R004 - DRAFT SEQUENCE - NOT INSTALLATION APPROVAL

Depth and sealing / review correction

05 / Install only the released material detail

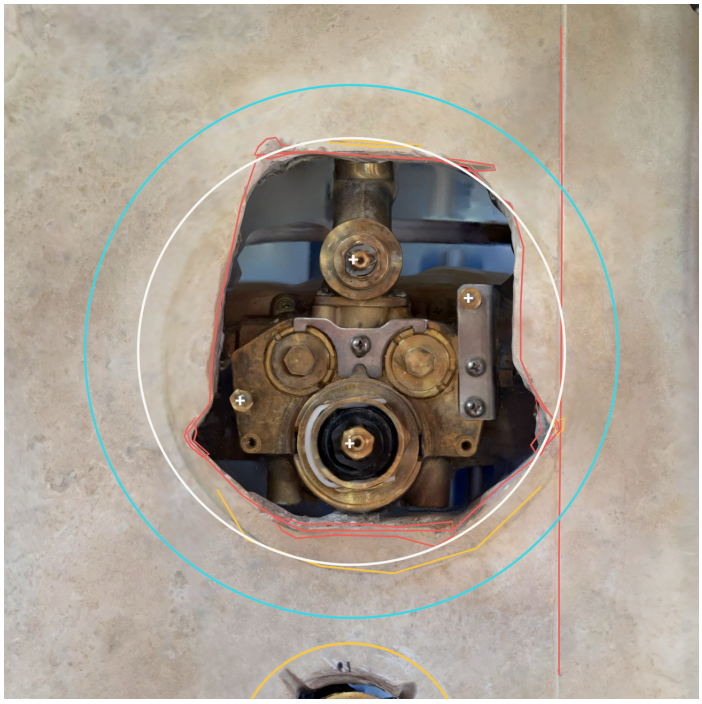
The current seated-cover trial has solid intersections and is rejected. No selected mortar, backing, sealant, finish or cure schedule exists. Do not install from this draft.

Control depth / diagnostic follow-up

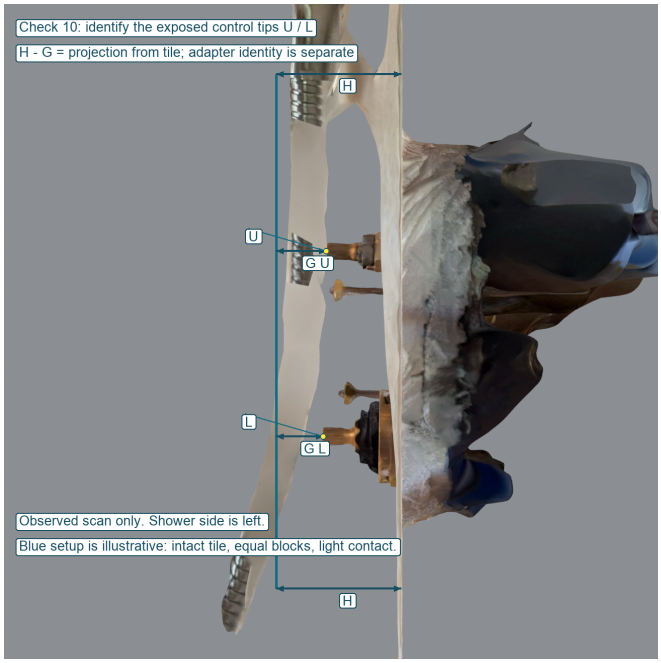
The user confirms excessive stud projection and reports rear bolt contact with wood. Trim studs thread into the valve; they do not need wood anchorage. Identify the same rear fasteners, framing/blocking and usable travel before selecting a remedy.

K-2973-KS specification p3: the labeled upper bare-tip and finished-wall dimensions imply a nominal upper-tip interval -6.3 to 27.0 mm from tile. Current comparison: 32.0 mm (conditional scan tip; identity and physical scale unverified). This is outside nominal interval if same bare tip. It is not a valve-relocation target.

Check 10 identifies the as-found tips/adapters and records block height H and both underside-to-tip gaps. H - G gives signed projection. The installer separately checks the plaster guard or documented axis datum. The 7/16-inch trim-stud limit does not apply to control stems.

Correct adapter and screw lengths must permit handle engagement and full cover/bonnet seating. An added backing plate changes that relationship again. Internal valve seals contain supply water; improper trim seating concerns external shower-water entry. Test these separately after the complete assembly is resolved.
